DOOSAN **Document Transmittal** Upper Trishuli-1 HEP (216MW)	**Date** **2022-03-10**	**DT No.:** **UT1-HEP-DHI-PC-D-0012**	**SHEET** **1 OF 1**

DOOSAN NEPAL **BRANCH OFFICE**	**Address & Contact No. :** **Four Square Building, Naxal,** **Kathmandu, Nepal (P.O Box : 1387)** **+ 977 1 692 3014**	**Project No.** **H20002**	**DOCUMENT DISPATCHED BY** **Courier Service** ☐ **Messenger** ☐ **Post-Air Freight** ☐ **Document System or E-mail** ■ **By hand** ■
DOCUMENT **DISTRIBUTION**	■ **POWER CHINA (Subcontractor)** ☐ **Doosan's Site Office**		
SUBJECT	**Review Note RN-0082_Arrangement Drawing of Diversion Tunnel**

REVIEW NOTE

Contractor	**Doosan Heavy Industries & Construction Co., Ltd.**		
Title of the Document	Arrangement Drawing of Diversion Tunnel, sheets 1-2		
Document No.	UT1-C-010-CVL-DG-42001	Revision	0C
Date of Documents	20.01.2022	Received Date	23.01.2022
Transmittal Form No.	UT1-HEP-DHI-D-0125		
Previous Review Date/Status	N/A	Prev. Review Note No.	N/A
Review Note No.	**RN-0082**	**Present Review Date**	**09.03.2022**
		Present Review Status	**RR**

GENGRAL PLAN OF DIVERSION TUNNEL

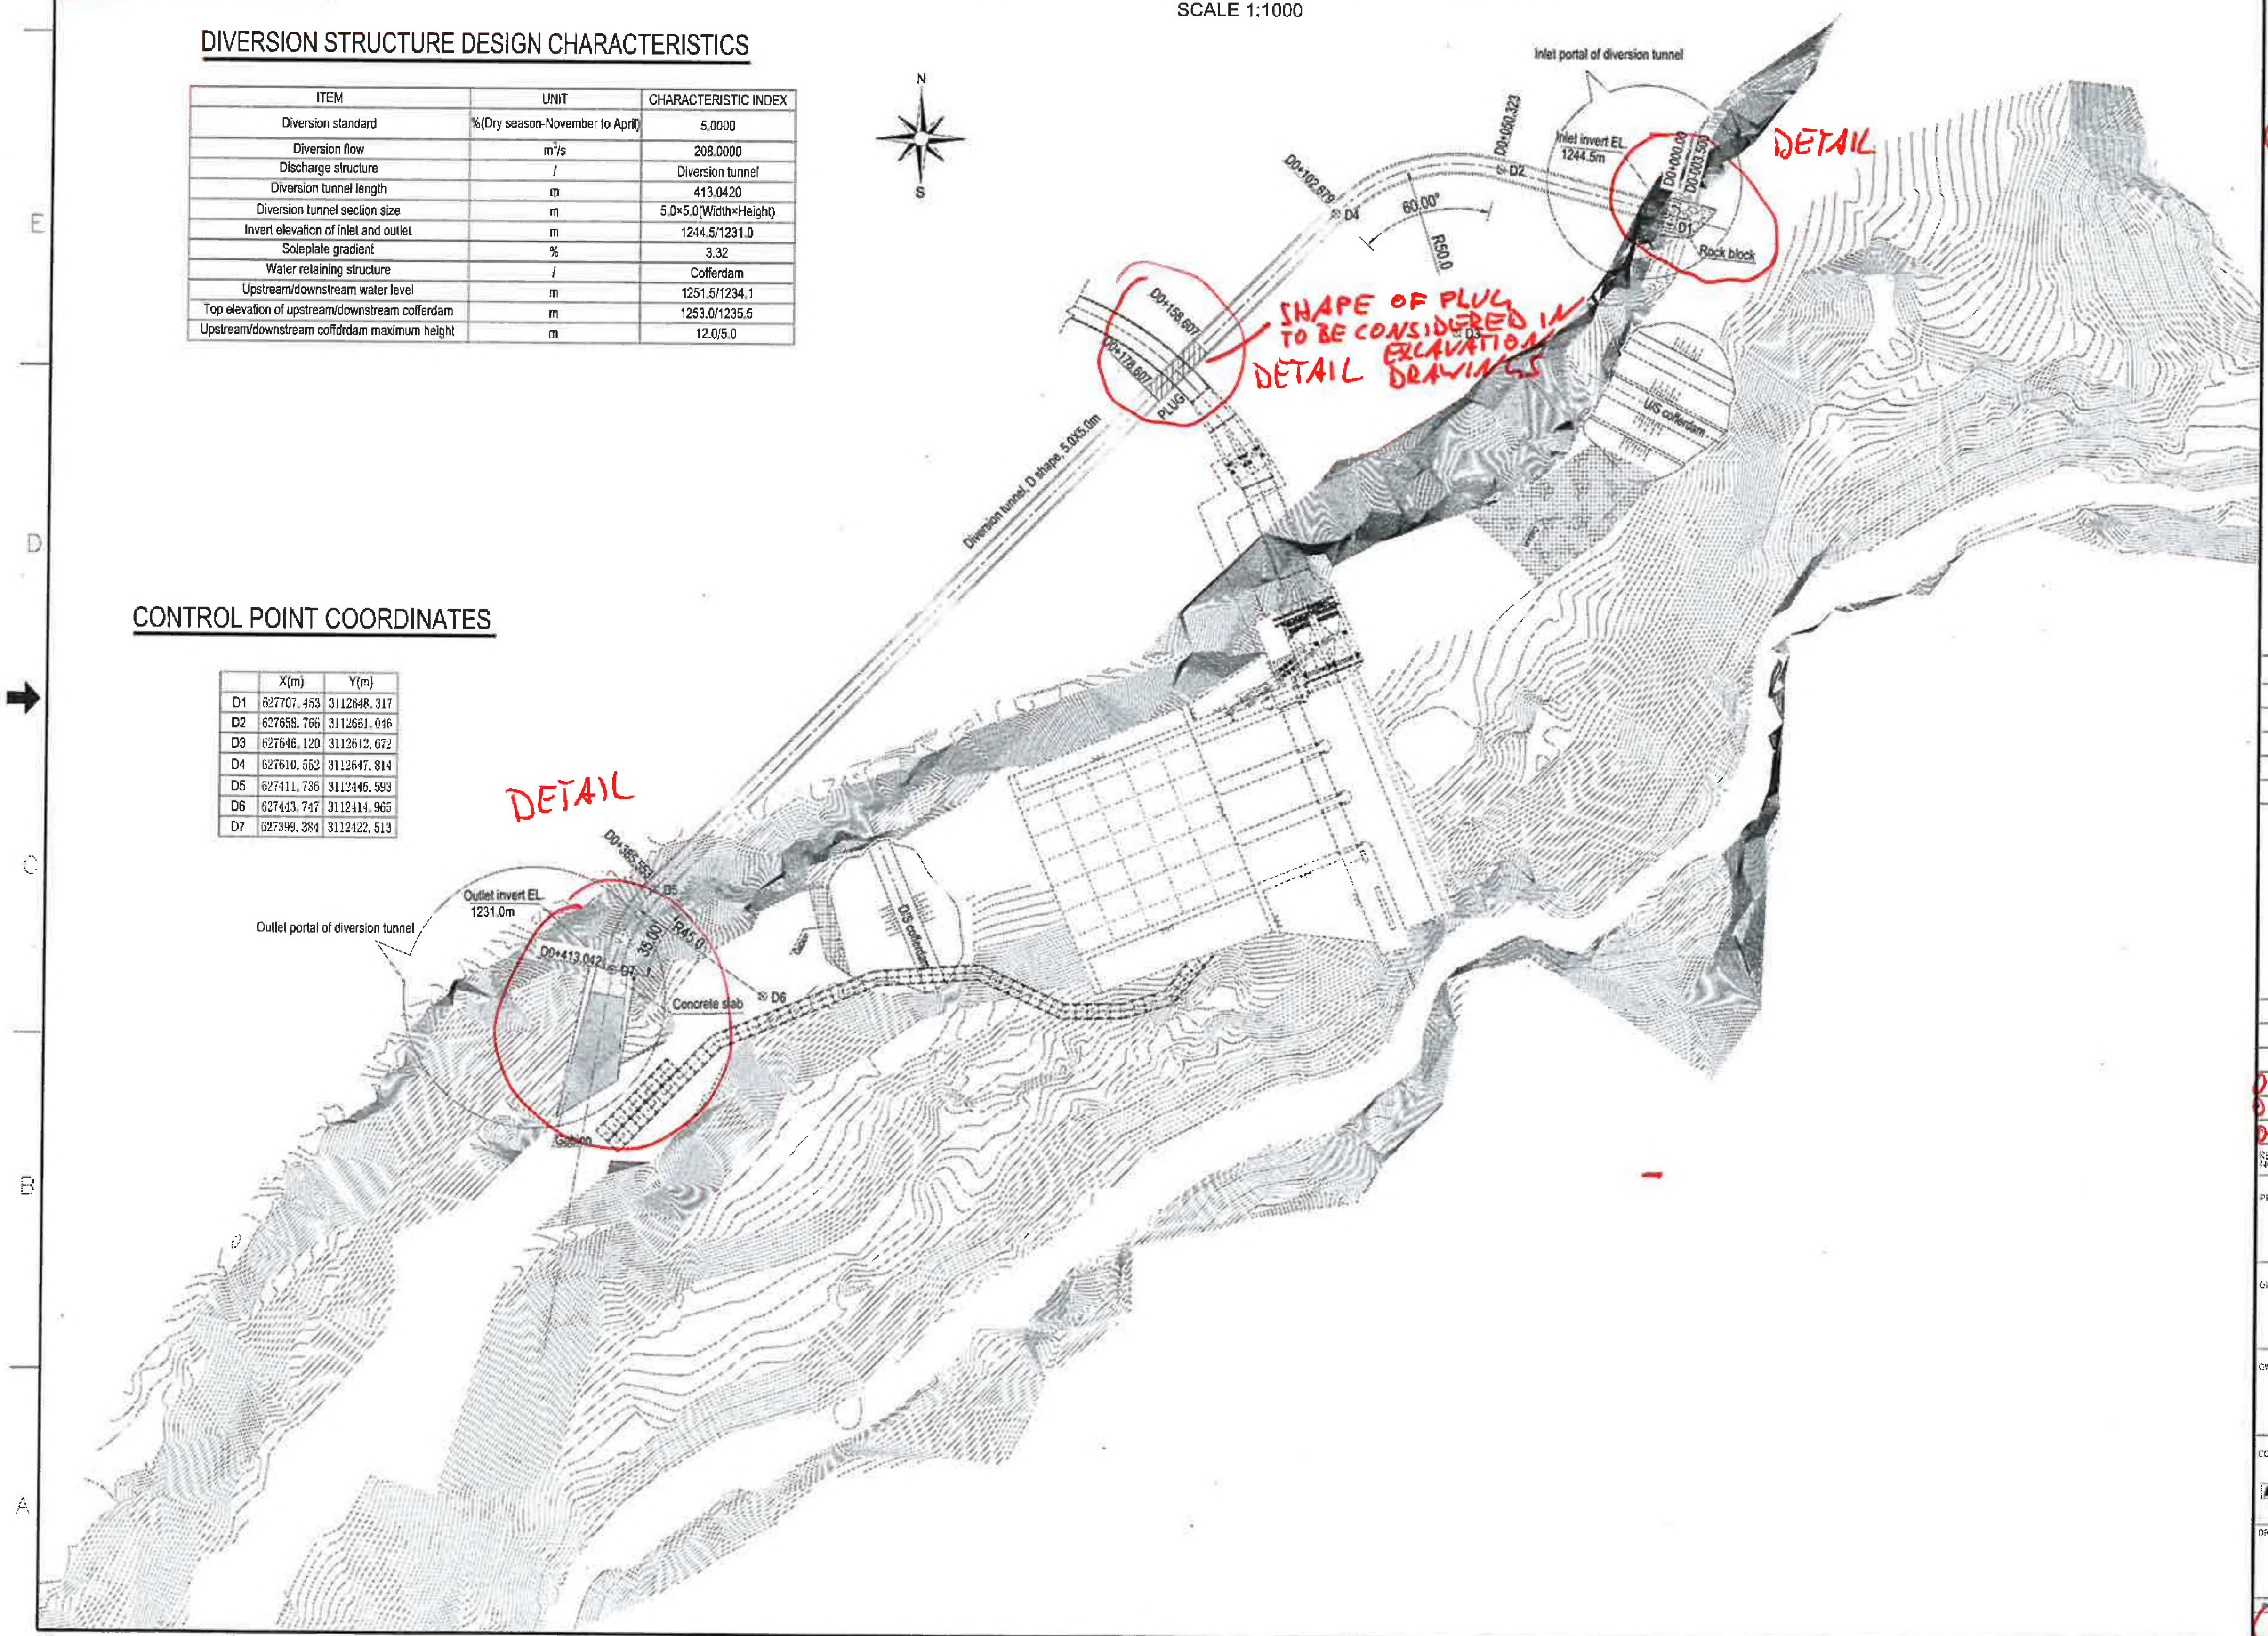
N
S
Inlet portal of diversion tunnel
Inlet invert EL. 1244.5m
D0+000.00
D0+003.50
D0+050.323
D0+102.679
D1
D2
D3
D4
60.00°
R50.0
Rock block
DETAIL
D0+158.607
D0+178.607
PLUG
SHAPE OF PLUG TO BE CONSIDERED IN EXCAVATION DRAWINGS
DETAIL
U/S cofferdam
Diversion tunnel, D shape, 5.0x5.0m
DETAIL
D0+385.553
D5
Outlet invert EL. 1231.0m
Outlet portal of diversion tunnel
R45.0
35.00
D0+413.042
D7
D6
Concrete slab
Gabion
D/S cofferdam

1.This set of drawings are the arrangement of diversion tunnel.
2.Elevations and chainages are in meter, other dimensions are in centimeter.
3.Structures shown on the drawing with the exception of diversion tunnel are sketches only.
4.The diversion structure design characteristics table is tentative ✓
~~5.The alignment etc., location of portals etc. are subject to approval~~ OK
6.Scale:

SCALE IS NOT SUBJECT OF A NOTE

LONGITUDINAL PROFILE OF DIVERSION TUNNEL

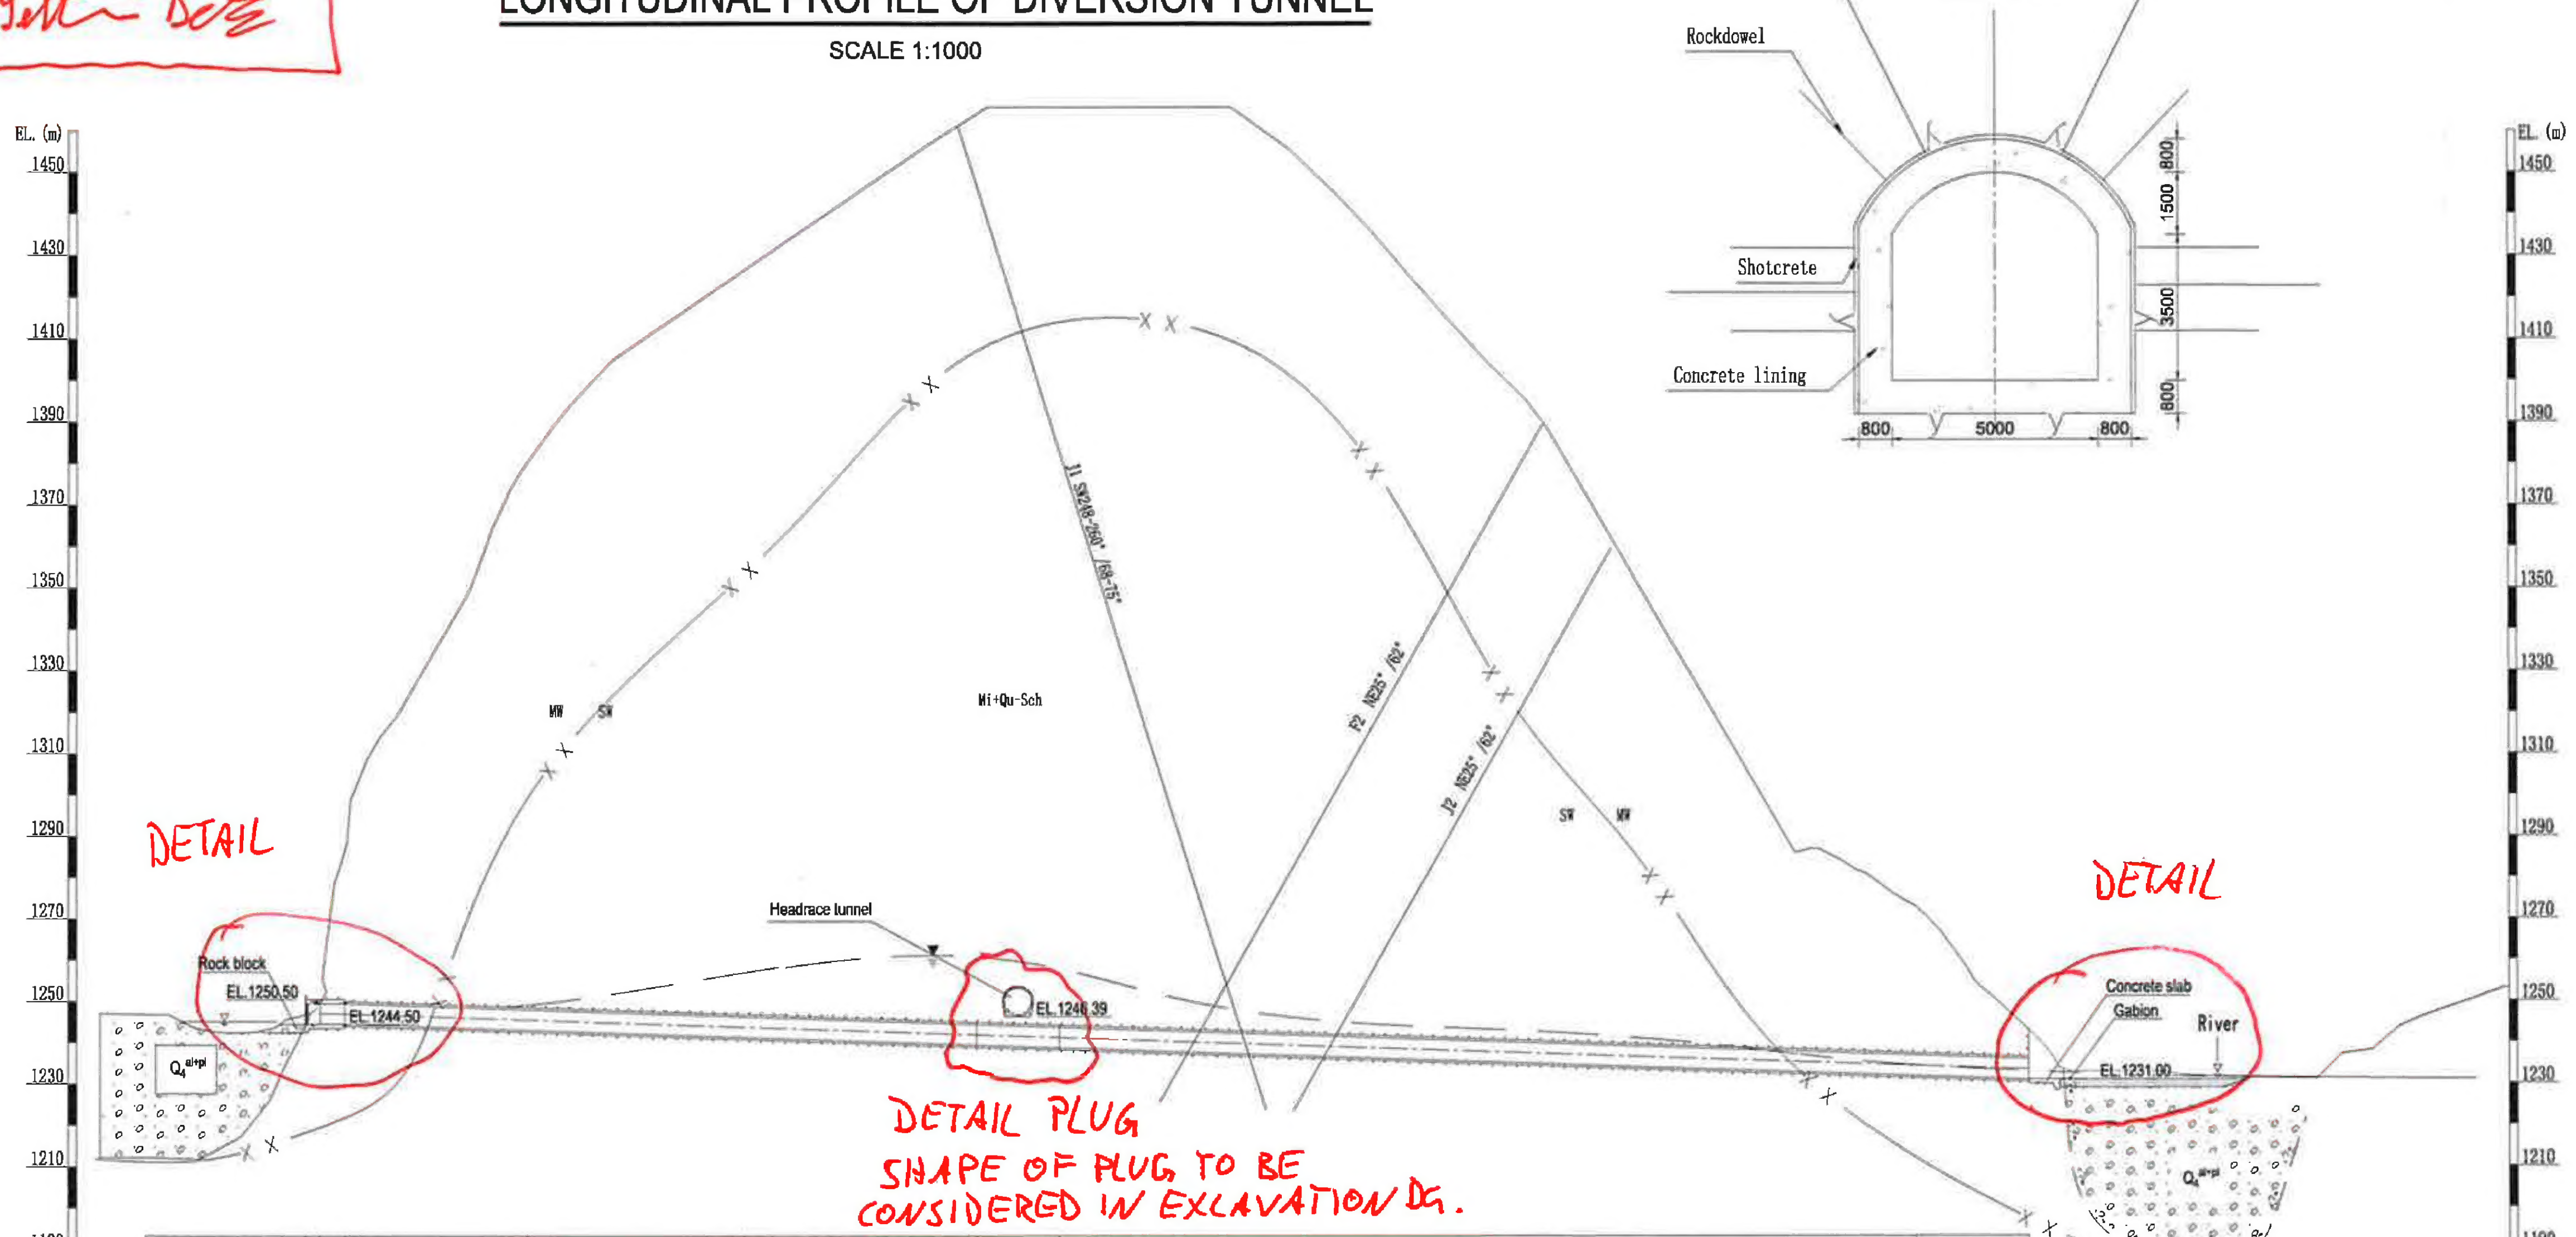
DETAIL PLUG
SHAPE OF PLUG TO BE CONSIDERED IN EXCAVATION DG.

~~4.Tunnel support and tunnel lining are subject to approval.~~ OK

→ NOT SUBJECT OF A NOTE

TYPICAL CROSS SECTION OF II

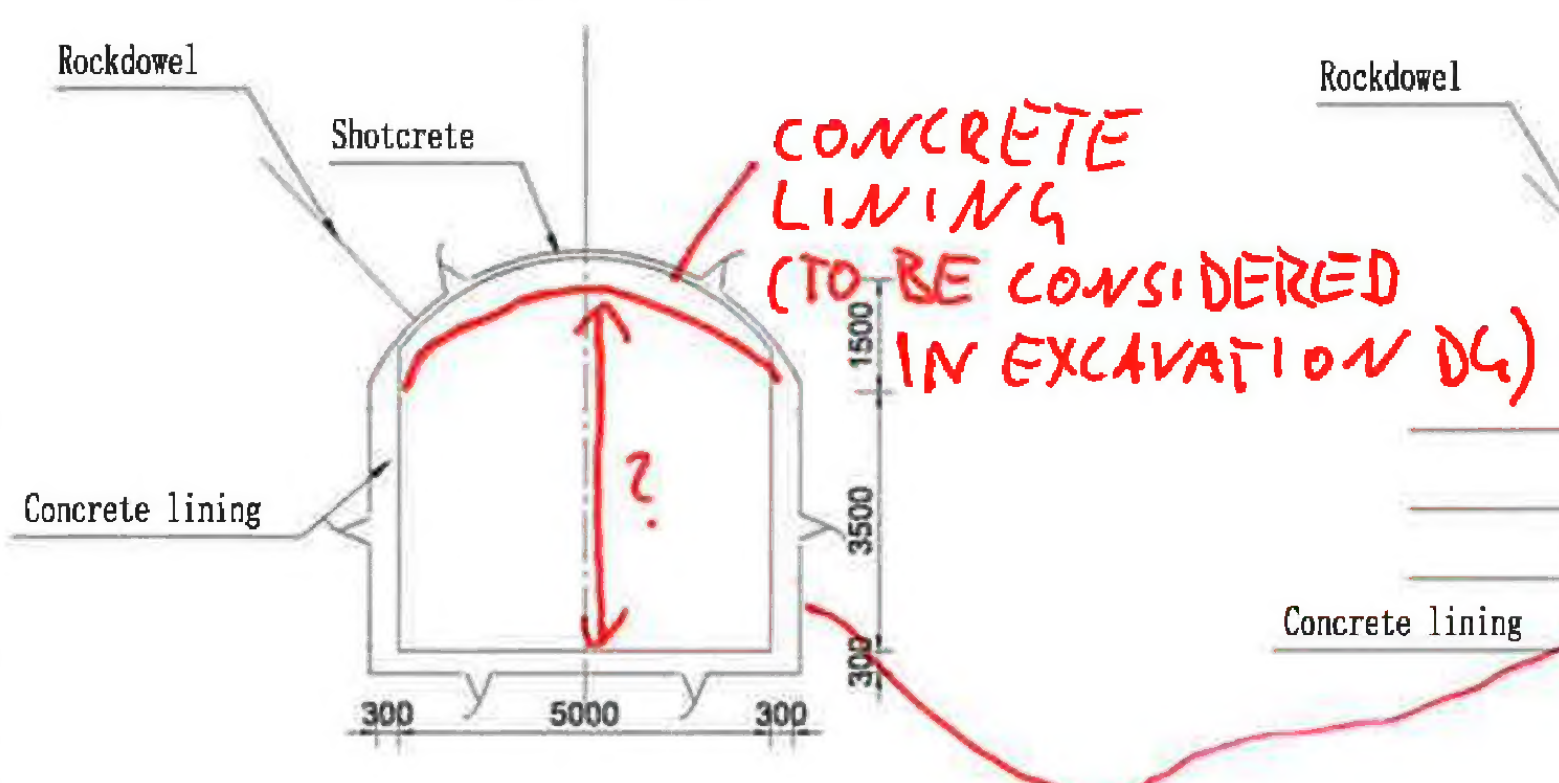
Rockdowel
Shotcrete
Concrete lining
1500
3500
300
300
5000
300
?

CONCRETE LINING (TO BE CONSIDERED IN EXCAVATION DG)

TYPICAL CROSS SECTION OF IIIa,IIIb

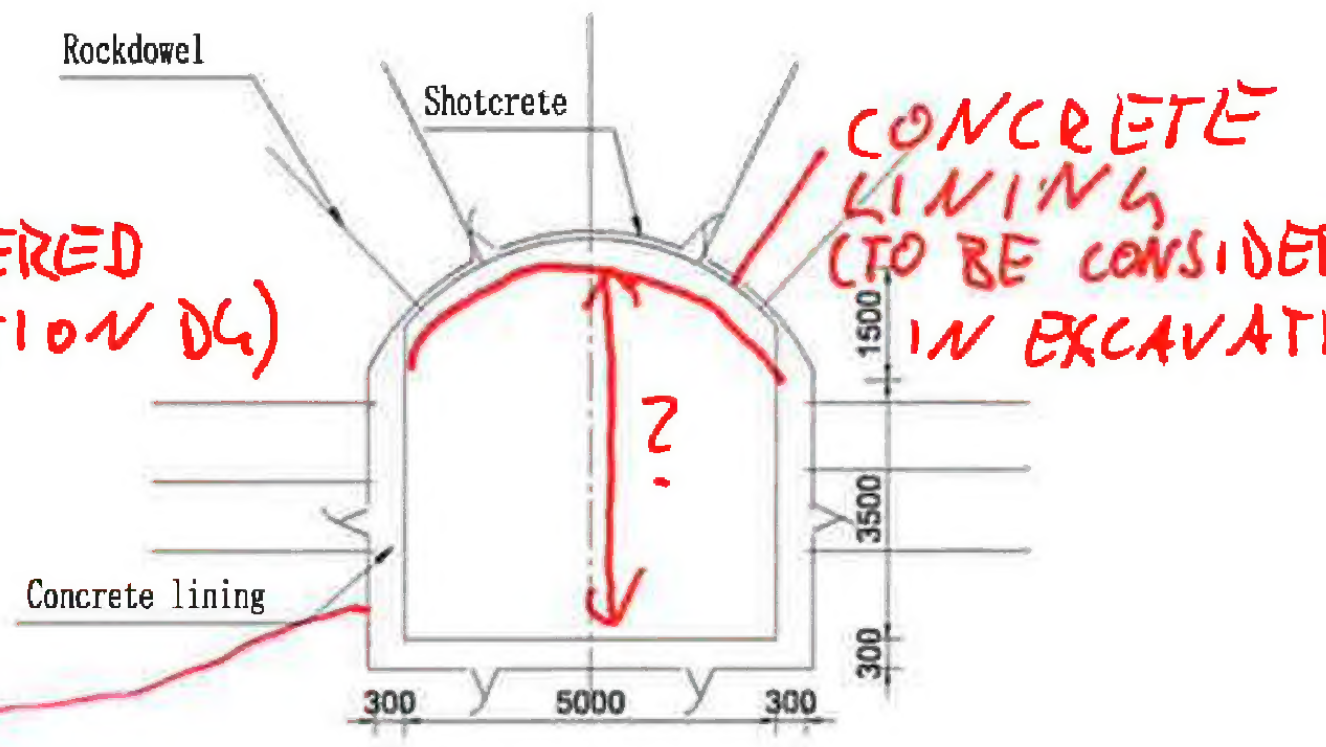
Rockdowel
Shotcrete
Concrete lining
1500
3500
300
300
5000
300
?

CONCRETE LINING (TO BE CONSIDERED IN EXCAVATION DG)

SHOTCRETE
